**PDU – RM3 / VAL0122989/SKC9194852**  
PANEL DISPLAY UNIT FOR THE RMS-EX1 SYSTEM  
Upgrade information

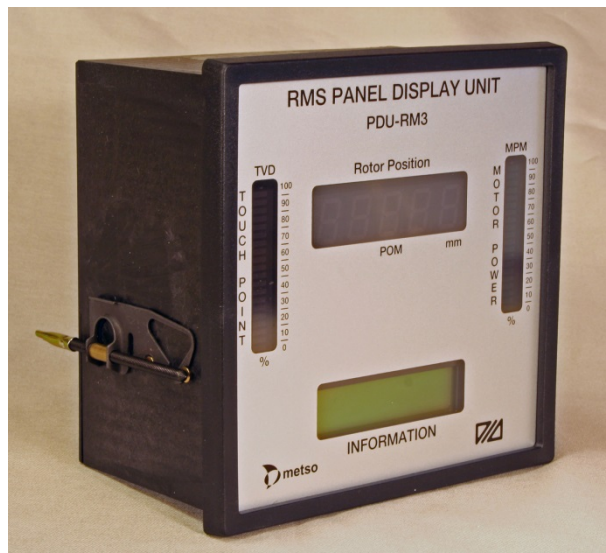
The resolution of MPM indication for the LDU-RM1 unit has been upgraded. As a consequence of this, the PDU-RM3 display has to be upgraded also.

The new version, 1.7 displays the MPM values on the LCD display with two decimals when selected. For full function the LDU-RM1 unit must have a software revision of 4.70 or later.

This update will be standard on all PDU-RM3 units delivered from Nov. 1, 2014. This includes serial no. 181 and higher.

“PDU-RM3 V1.7” is indicated for two seconds after start up.
